Access Compliance Report Public Rights-of-Way (Curb Ramps)

Intersection ID: 19543 Main Street: SCOFIELD_RD Cross Street: TOPPING_PL Location:

ADA ID: B94738B5B1FA Ramp Type: ParaDiag Initial Pass/Fail: Fail Overall Compliance: No Severity Score: 48.75

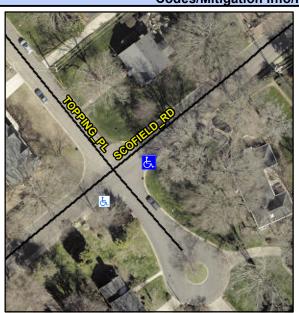
R304.5.1, R304.3.2, R304.5.3

Field Measure Compliance Description		Data	Comp	oliance Description	Data
N/A	Ramp Length LT (in)	44.0	N/A	Ramp Length RT (in)	43.0
Yes	Ramp Width LT (in)	52.0	No	Ramp Width RT (in)	28.0
No	Ramp Slope LT (%)	10.8	Yes	Ramp Slope RT (%)	8.2
No	Ramp XSlope LT (%)	2.8	Yes	Ramp XSlope RT (%)	0.5
N/A	Landing Length (in)	N/A	N/A	DWS Provided?	N/A
N/A	Landing Width (in)	N/A	N/A	DWS Contrast?	N/A
N/A	Landing Slope (%)	N/A	N/A	DWS Length (in)	N/A
N/A	Landing X Slope (%)	N/A	N/A	DWS Full Width?	N/A
N/A	Landing Curb? (Y/N)	N/A	N/A	DWS Offset (in)	N/A
N/A	Shared Landing?	N/A			
N/A	Gutter Ponding?	N/A	N/A	Gutter Slope (%)	N/A
N/A	Gutter Lip Ht (in)	N/A	N/A	Gutter X Slope (%)	N/A
N/A	Painted X Walk1?	No	N/A	Painted X Walk2?	No
	X Walk 1 Direction	To NW		X Walk 2 Direction	To SW
N/A	X Walk 1 Width (in)	N/A	N/A	X Walk 2 Width (in)	N/A
	X Walk 1 Slope (%)	3.6		X Walk 2 Slope (%)	5.2
	X Walk 1 X Slope (%)	7.1		X Walk 2 X Slope (%)	9.7

Remove & Replace Curb Ramp With Two New Directional Ramps or Equivalent.
